City of Santa Barbara

PLANNING COMMISSION STAFF REPORT

REPORT DATE: February 9, 2006
AGENDA DATE: February 16, 2006
PROJECT ADDRESS: 1425 Mission Ridge Road (MST2005-00098)
TO: Planning Commission
FROM: Planning Division, (805) 564-5470
 Jan Hubbell, AICP, Senior Planner *JH*
 Jo Anne La Conte, Assistant Planner *JAL*

1425 MISSION RIDGE ROAD
MODIFICATION AND NEIGHBORHOOD PRESERVATION ORDINANCE
FEBRUARY 16, 2006

Down By
Steel
L-4
CR 4
JOS NP 0504

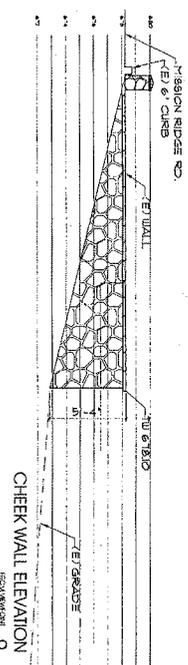
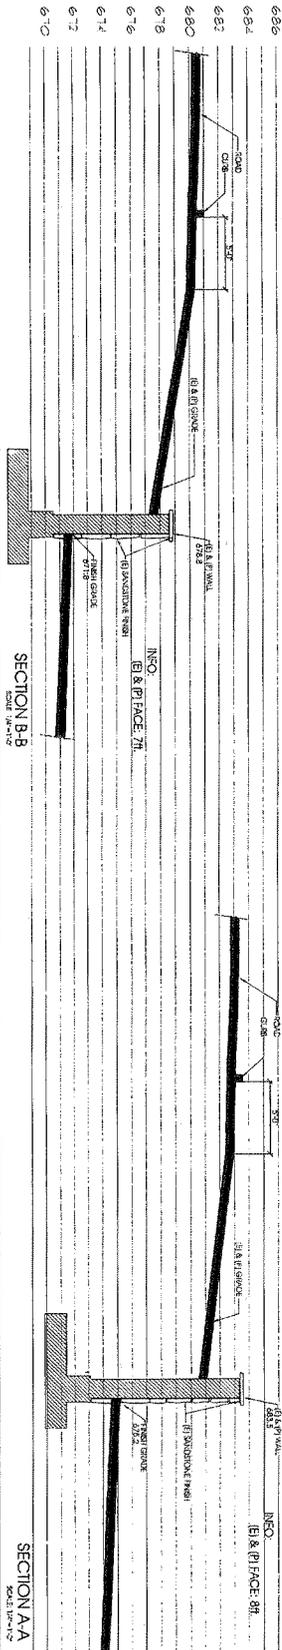
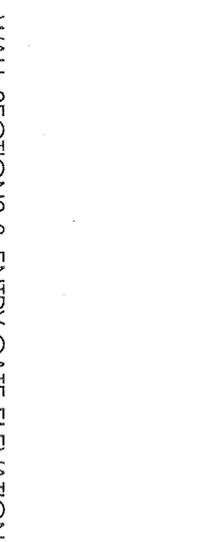
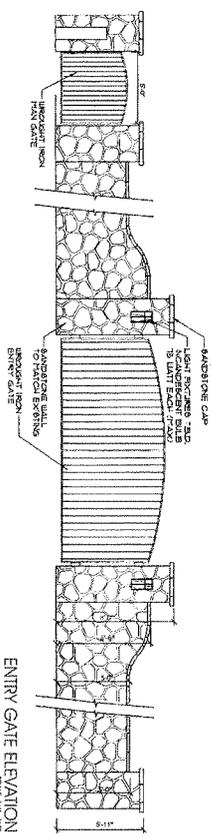
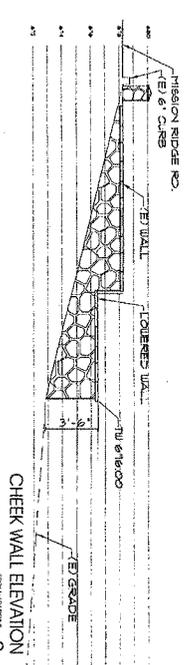
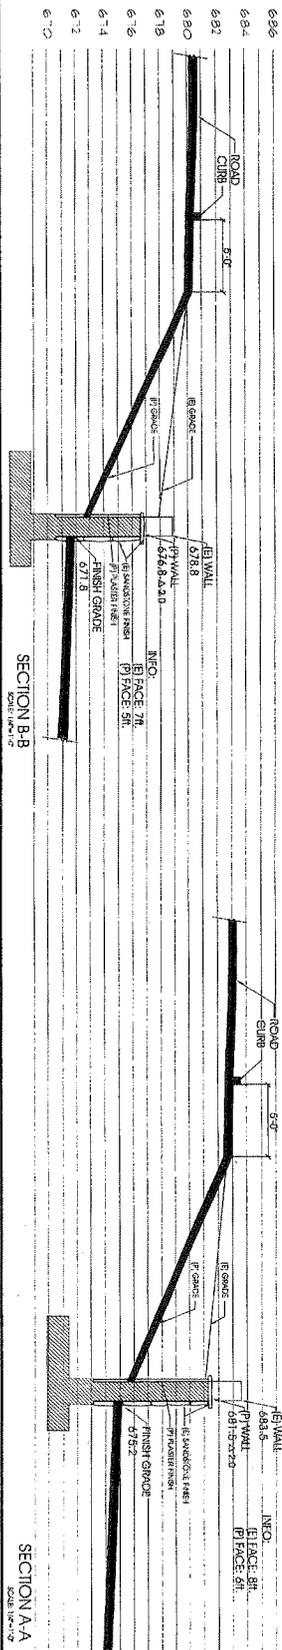
Option B also reduces the height of the wall to a range of 3.5 to 6.42 feet in height, but not to the recommended maximum of 5 feet in height, proposes to lower the cheek wall but not to eliminate it and reduces the flattened slope.

- 1) The Board finds the applicant has made significant steps in re-establishing the original character of the right-of-way and street frontage.*
- 2) Increase the landscaping (in amount and size) and provide additional landscaping on the west side of the driveway to create a balance of the landscaping palette.*

- 3) The Board supports the wall at the property line with a maximum of five foot height from the original re-created grade.*
- 4) Eliminate the cheek wall at the east side driveway. The Board would support the modification request for the entry wall with the elimination of the previously described wall section.*

The project is an as-built construction of a 220 linear foot sandstone wall with a proposal to add approximately 55 feet of sandstone wall with gates at the drive. Two options are shown on the enclosed plans (Sheet L-4 dated 9-13-05). Option A proposes to leave the wall at its current height. Option B is to reduce the height of the wall to a exposed height of 5 feet on the south (residence) side and an exposed height of under 4 feet on the north side per the request of the Architectural Board of Review (ABR).
